Docket No. 52-021  
MHI Ref: UAP-HF-12021

**Subject: MHI's Response to US-APWR DCD RAI No. 839-6130 Revision 3 (SRP 06.02.02)**

Response to Request for Additional Information No. 839-6130  
Revision 3

Figure 2: Water Volume Inside Openings on 2<sup>nd</sup> Floor

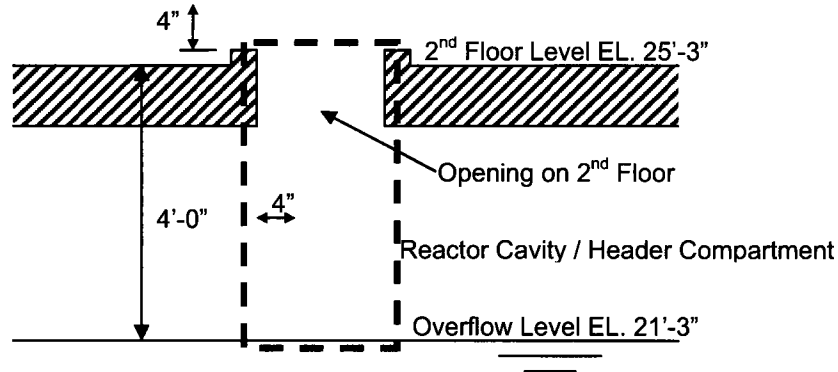
In addition, request MHI clarify if water in transition from the 25' 3" elevation through the ten, 18 inch transfer pipes to the RWSP minimum water level elevation (~ 4 foot elevation) was accounted for in the calculation of "Return Water on the way to the RWSP" (MUAP-08001 Table 3-10)? If this water in transition was not accounted for, provide an update to Table 3-10 and explain how this volume of water impacts the margin depicted in MUAP-08001-P (R5) Figure 3-11?

The height of water overflowing the weirs around the floor openings is 4 in. as the water enters the opening. The water thickness along the inside of the opening will be greater at the top of the opening due to gravity and will decrease with the falling height because the flow rate is constant. Therefore, a water thickness of 4 in. is conservatively assumed to exist from the 2<sup>nd</sup> floor to the lower floor as indicated by red dash line in Figure 2.

The sum of the perimeters of the openings on the 2<sup>nd</sup> floor is about 100 ft (See Figure 1). So the water volume flowing through the openings is 134 ft<sup>3</sup>.

The water volume is account in the “Volume of water in piping and floor opening on 2nd floor” of Attachment 1 of RAI answer to question No. 06.02.02-70.
